#### **CHANGE ORDER**

West Irvine Pavement

Improvements Irvine, Kentucky BG 22-178 RTA 2143

COP 04 Revised 02

FO 01 - DS3 & 4 Storm Rims and Inverts Clarification

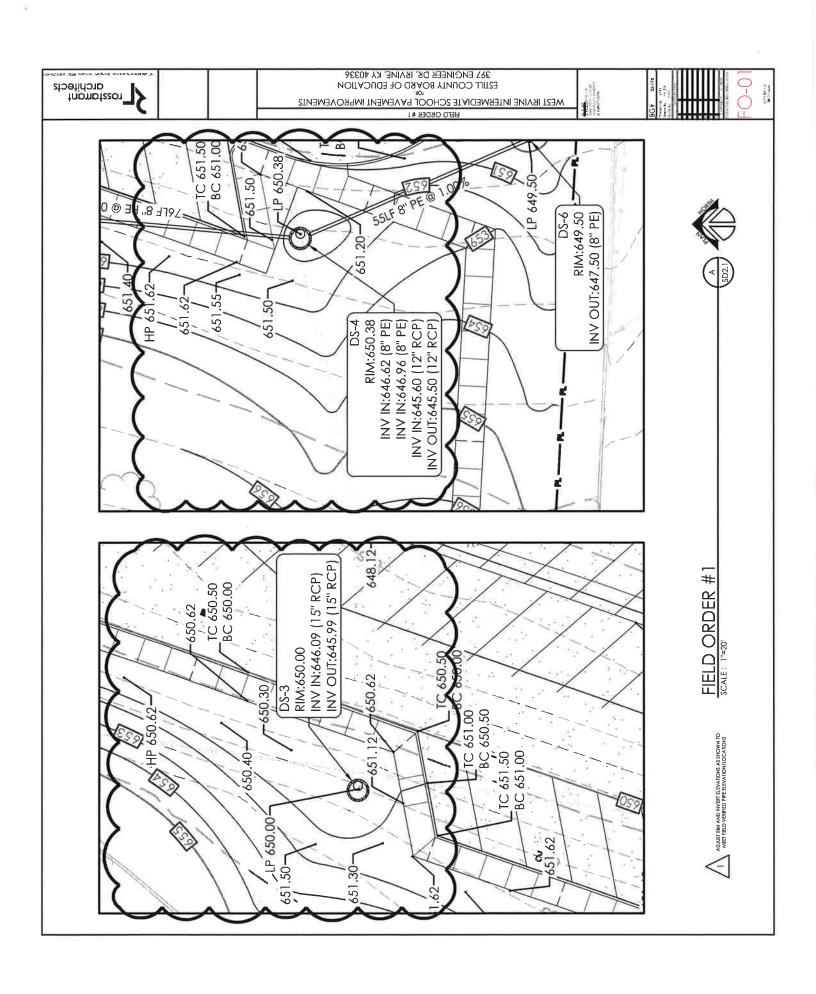
Refer to the attached sketches for rim and invert intent

clarifications at DS 3&4.
